INTER-DEPARTMENTAL REVIEW COMMITTEE REPORT

Resubdivision of Lot 1 in Pehrson Second Resubdivision – 80 Yorktown

September 21, 2015

SUB 15-03

EXHIBIT A: PLAT OF RESUBDIVISION

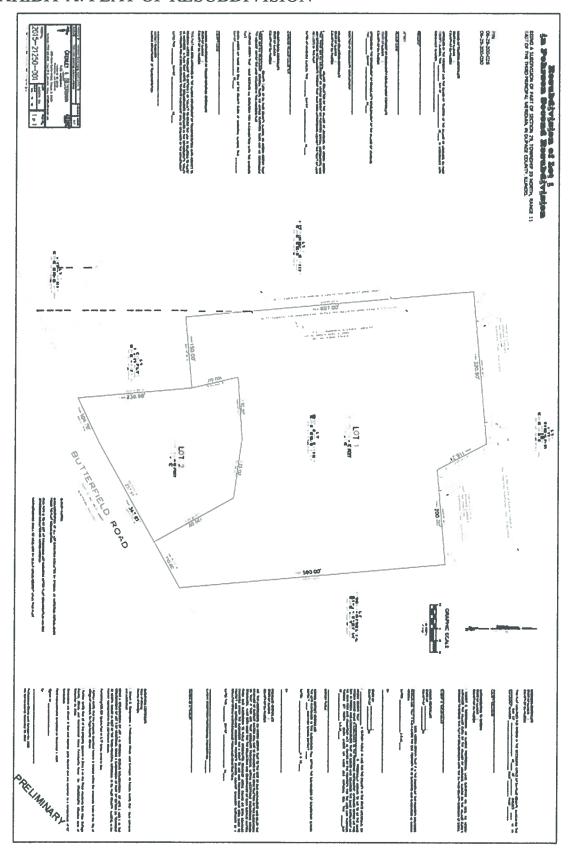
As engineering has not been submitted yet, the property owner may consider adding an easement on Lot 1 resub of lot 5 for the sanitary sewer service line that will serve the new Lot 2 for future maintenance reasons, if Lot 1 were to be sold off at some point in the future.

The Drainage Certificate is to be removed from the plat by the surveyor.

A public sidewalk is required along Butterfield Road as a Major Development per Village Code Section 154.306. If desired, this sidewalk may be constructed on private property provided that it is contained in a related easement.
